NAME DRAWN	ZitD	DATE	2023-11-21	TITLE:	SUBEC AB Adj. Roller Cross 45, Ø1-40mm, D25, HRX		
PROJECT NAME:		FINISH:					
PROJECT NO:		DEBUR AND BREAK SHARP EDGES		ARTICLE NO:	13031		DWG NO.
MATERIAL:					3-400327-00		A4
				DO NOT SCALE DRAWING	WEIGHT:	SHEET 1 OF 1	
					g	3-400327-00_13031

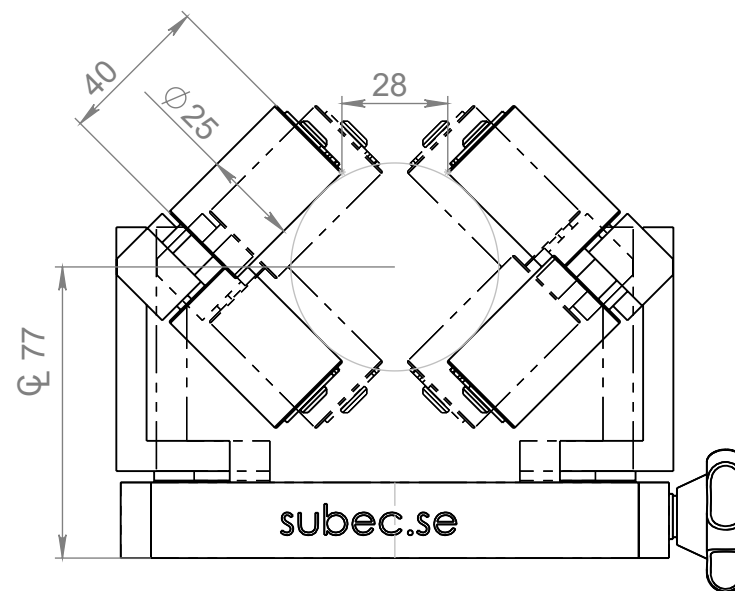
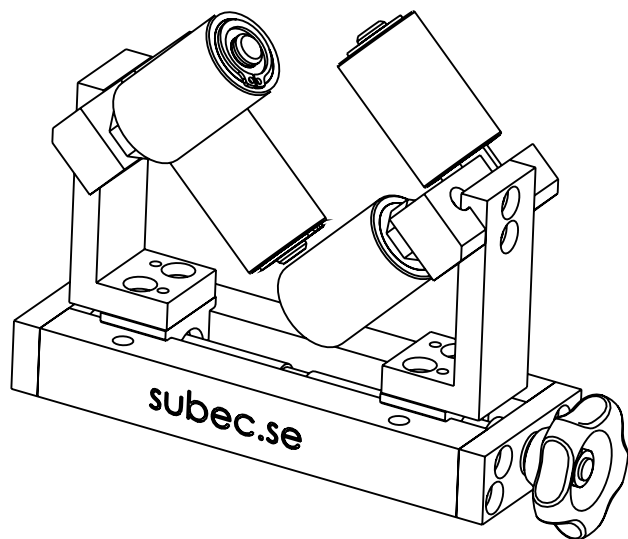
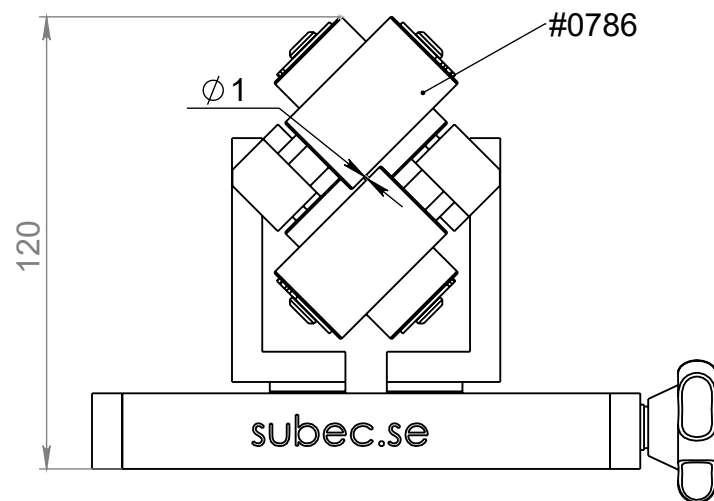
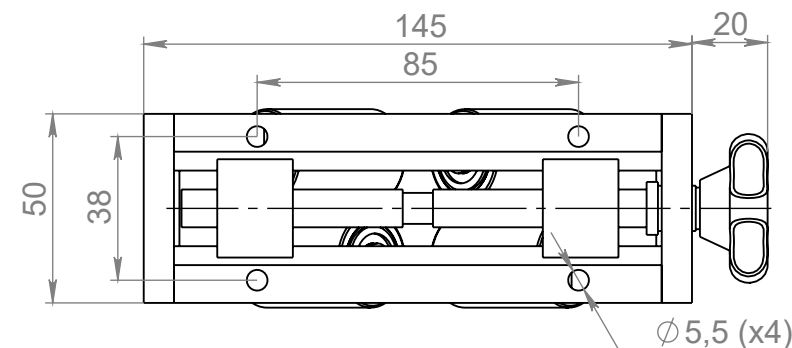
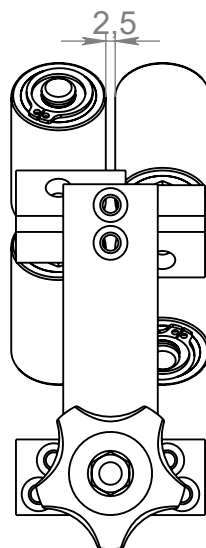
1. Based on 6972C but with longer block, for top opening 25mm
2. Changed side plates, add 2pcs holes for M5 bolt instead 2 pcs pin.
3. Add 2 pin holes for slider and roller holder.
